UNITED STATES PATENT AND TRADEMARK OFFICE

Application No.	Applicant(s)	
	10/735,441	FAISST ET AL.	
Office Action Summary	Examiner	Art Unit	
	Amy J. Sterling	3632	
The MAILING DATE of this communication appears on the cover sheet with the correspondence address Period for Reply			
A SHORTENED STATUTORY PERIOD FOR REPLY IS SET TO EXPIRE 3 MONTH(S) OR THIRTY (30) DAYS, WHICHEVER IS LONGER, FROM THE MAILING DATE OF THIS COMMUNICATION. - Extensions of time may be available under the provisions of 37 CFR 1.136(a). In no event, however, may a reply be timely filed after SIX (6) MONTHS from the mailing date of this communication. - If NO period for reply is specified above, the maximum statutory period will apply and will expire SIX (6) MONTHS from the mailing date of this communication. - Failure to reply within the set or extended period for reply will, by statute, cause the application to become ABANDONED (35 U.S.C. § 133). Any reply received by the Office later than three months after the mailing date of this communication, even if timely filed, may reduce any earned patent term adjustment. See 37 CFR 1.704(b).

This is the second non-final Office Action for application number 10/735,

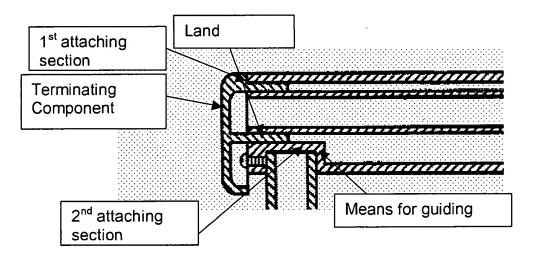
Claims 1, 6-9, 14 and 15 are rejected under 35 U.S.C. 102(b) as being anticipated by United States Patent No. 5632049 to Chen.

Chen teaches an arrangement for attaching articles including a wall-mounting rod (40) that has a continuous, guiding profile, extending over a full length of the wall mounting rod between ends and at least one bracket (42) wherein the arrangement leaves clear that part of the guiding profile used for guiding the slide the at least one bracket has two attachment sections one each at least near each of the ends, one of which is configured for attaching a terminating collar component (See Drawing Below) by a form fit and a means for guiding (See Drawing Below) the wall mounted rod sections the sections which are separated by a land joint (See Below).
